Add 3" Drive jumper on 09FLP Ver: 03 / Ver:09

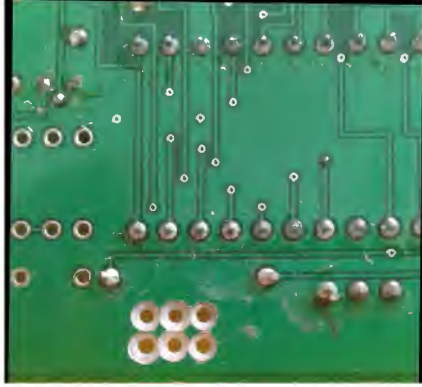
First cut the following two traces on the component side.

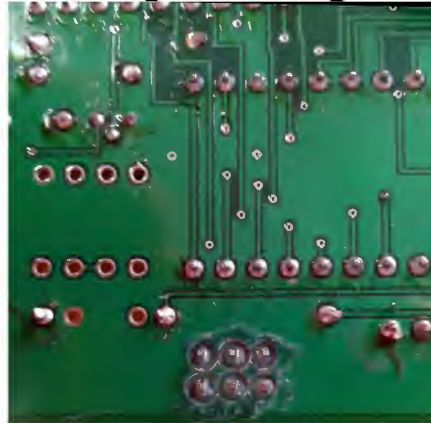
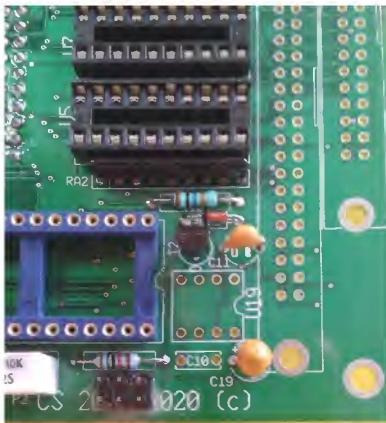
Then drill the 1.2mm holes for a 2x3 Pin Header.

The jumpers come below R5 for the use of DC2 connectors.

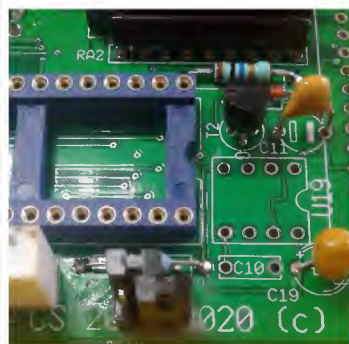
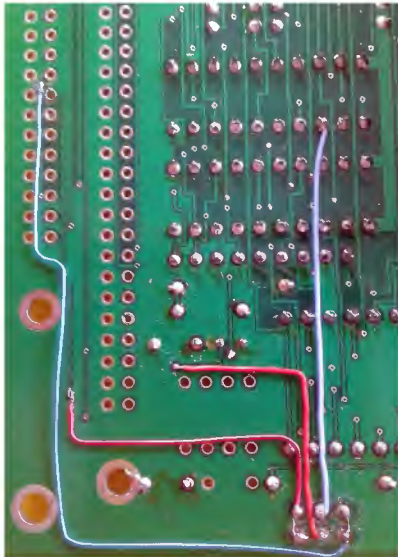
And remove the ground layer with a 3mm drill on both sides.

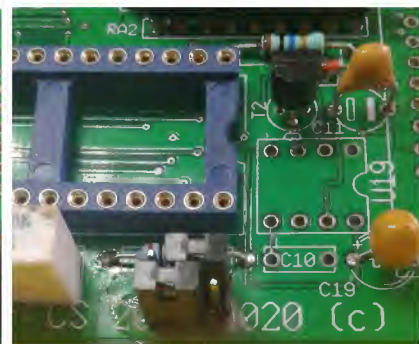
Glue the 2x3 Pin Header on the print component side.

Clean the pins on the solder side.

Now connect the following wires, use the via's and pin-3 U7.
